Re: CA R.18-10-007
CalAdvocates-PacifiCorp-2021WMP-04

Please find enclosed PacifiCorp's responses to CalPA data requests 4.1-4.9. Also provided is Attachment CalPA 4.1.

PacifiCorp's 2021 Wildfire Mitigation Plan (WMP)

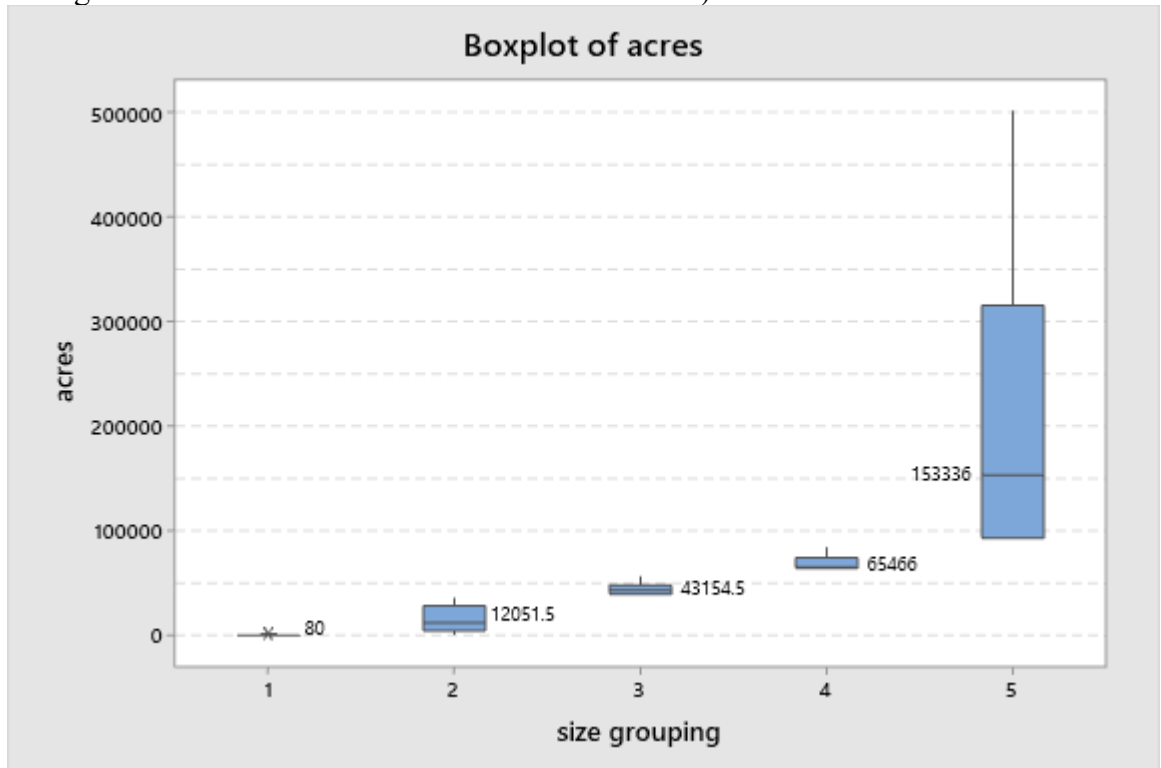
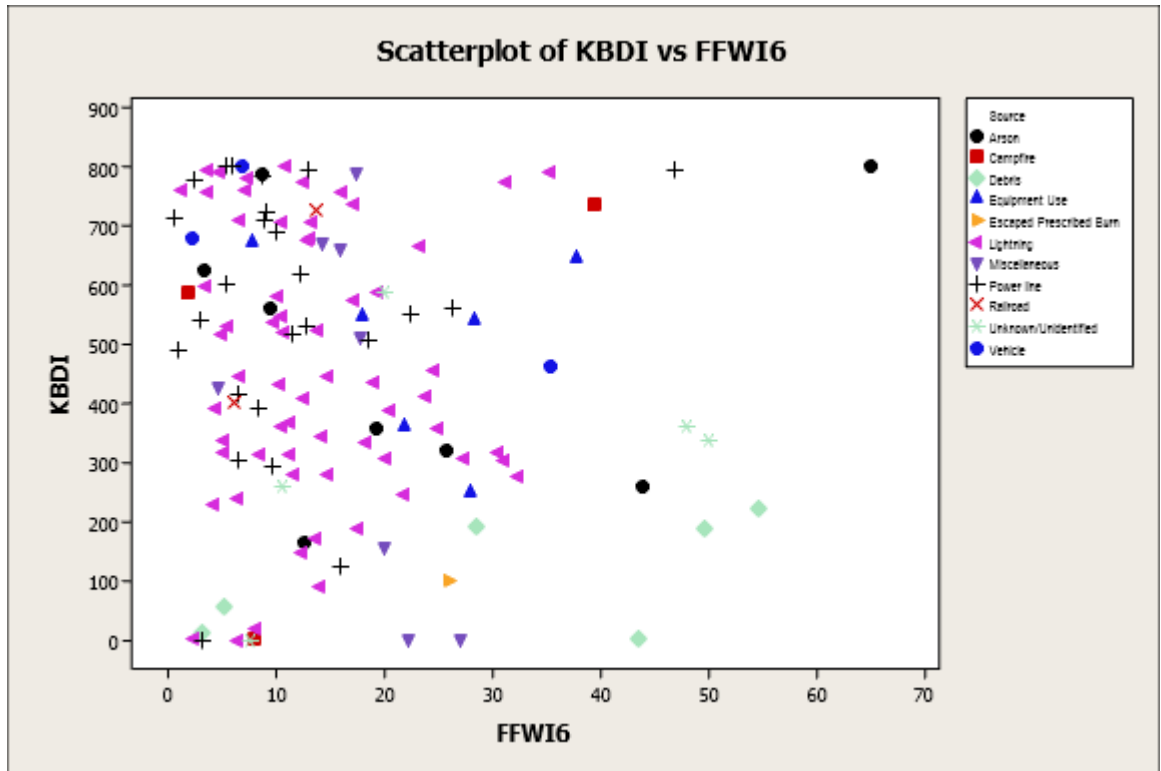
Provide the analysis that PacifiCorp used to select the numerical PSPS Watch thresholds for:

- (a) Hourly Fosberg Fire Weather Index.
- (b) The Keetch-Byram Drought Index.
- (c) Forecasted sustained wind speeds.
- (d) Forecasted wind gust speeds.

- (a) For subparts (a) and (b), in order to establish a stable fire weather value from which to initiate Public Safety Power Shut-off (PSPS), the Company utilized the Fosberg Fire Weather Index (FFWI) but averaged it over six hours (to recognize a standard burn period often considered by fire scientists) and limited the potential for short term activation of a PSPS for the fire season (June-early October). The Company performed analysis of this metric's ranges to determine a level at which FFWI6 should be considered, using a basic histogram as shown below.

Then, the Company analyzed weather conditions, fire sizes, and ignition sources for 176 fires which occurred in northern California (north of the 40th parallel), segmenting the fires into size families (1-5, with 4 and 5 being targeted as large acreage that would set a threshold for PSPS activation).

After further evaluating fire history as discussed in subpart (b) below, including assessment of the graphic below, the Company established a FFWI6 threshold of 30 as a key trigger.
